IN THE DRAWINGS:

REMARKS

This Amendment is submitted in response to the Office Action dated June 22, 2005. In the Office Action, the Patent Office objected to the drawings under 37 CFR §1.83(a) and to Claim 6 under 35 U.S.C. §112, first paragraph, for failing to comply with the written description requirement. Additionally, the Patent Office rejected Claims 1-3, 7, 9, 10, 14 and 18 under 35 U.S.C. §102(b) as being anticipated by *Miller* (U.S. Patent No. 1,780,269); Claims 8, 12 and 13 under 35 U.S.C. §103(a) as being unpatentable over *Miller*; Claims 4, 11 and 19 under 35 U.S.C. §103(a) as being unpatentable over *Miller* in view of *Marovich* (U.S. Patent No. 4,068,421); Claims 5 and 17 under 35 U.S.C. §103(a) as being unpatentable over *Miller* in view of Japanese Patent No. 2002-146913 to *Kawarazaki*; and Claims 15, 16 and 20 under 35 U.S.C. §103(a) as being unpatentable over *Miller* in view of *Lynch* (U.S. Patent No. 3,670,466).

FIG.3A

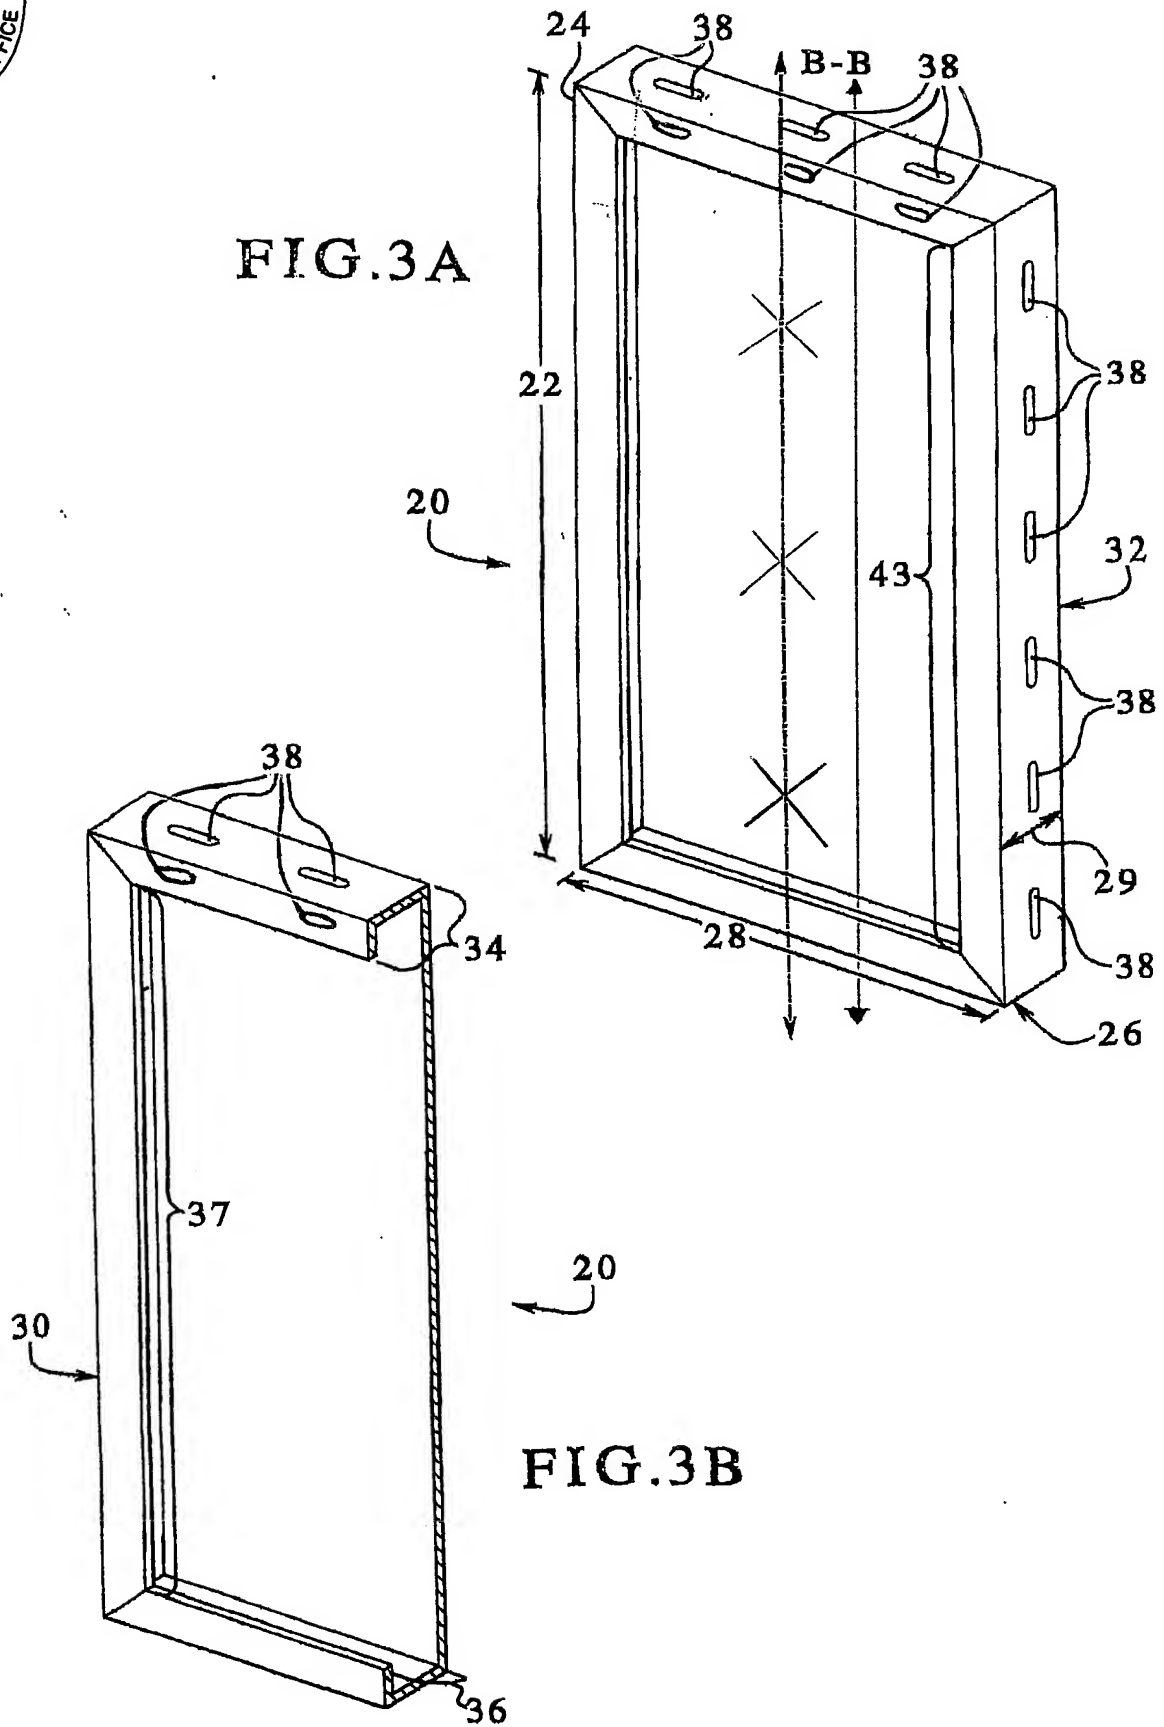
FIG. 3A has been corrected as shown in the Replacement Drawing Sheet and as shown in red in the Annotated Sheet Showing Changes in the attached Appendix.

In the Office Action, the Patent Office objected to the drawings as failing to show every feature of the invention specified in the claims. Namely, the Patent Office asserts that Fig. 6 shows an element labeled "46" which should be labeled "4b". In response to the objection, Applicant amended Fig. 6 by labeling the element "4b". Further, the Patent Office asserts that Fig. 3A and Fig. 3B fail to show the slots on the roof panels extending parallel to the body as illustrated in Fig. 5. Accordingly, Applicant amended Fig. 3A and Fig. 3B to show the slots illustrated by Fig. 5. The slots on the roof panels extending parallel to the body as illustrated by Fig. 5 are disclosed in the specification as filed. Specifically, page 9, lines 19 and 20 state: "Slots 38 may be provided within the section 34 and/or the section 36." Applicant submits that the amendments to Fig. 3A, Fig. 3B and Fig. 6 overcome the objections by the Patent Office. Notice to that effect is requested.

FIG.3B

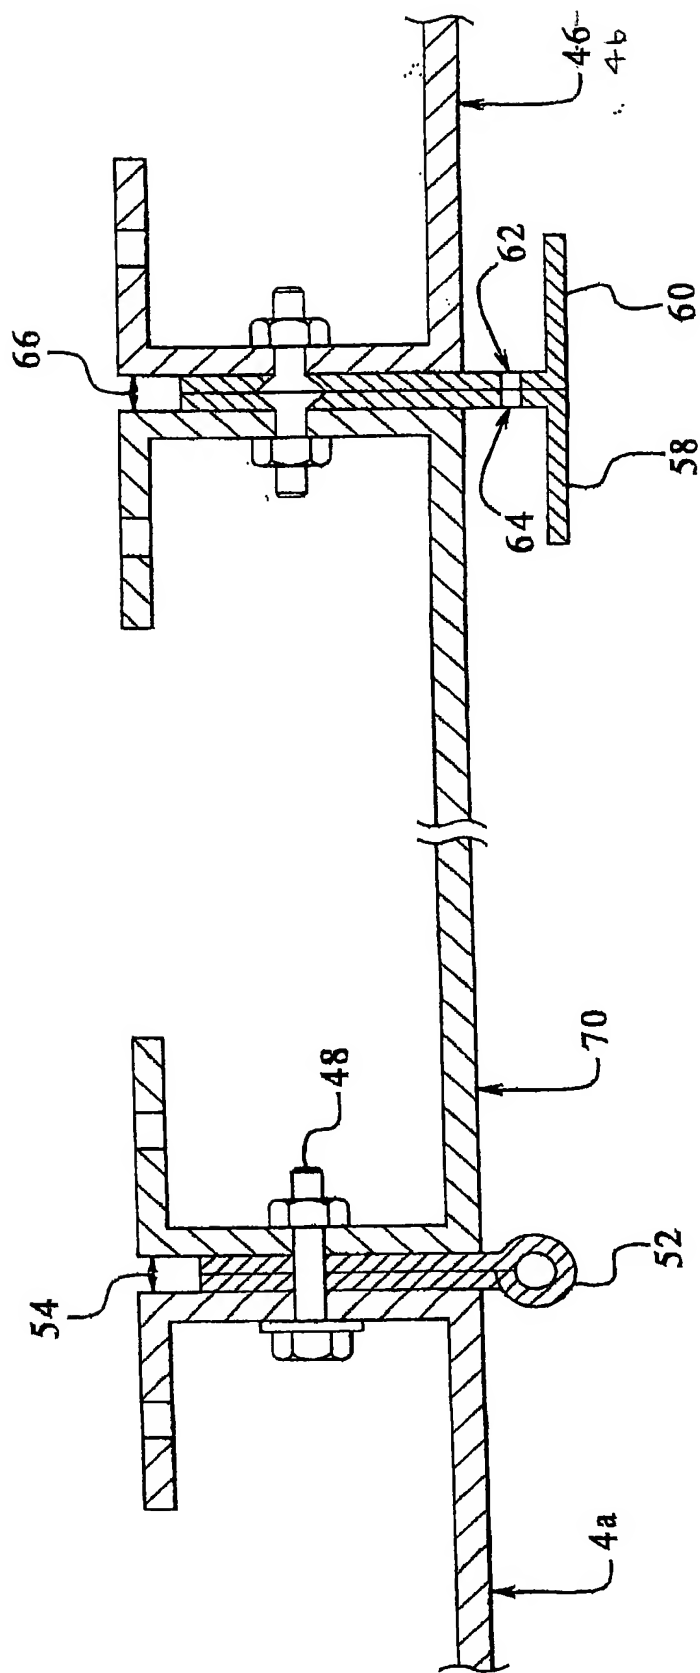
FIG. 3B has been corrected as shown in the Replacement Drawing Sheet and as shown in red in the Annotated Sheet Showing Changes in the attached Appendix.
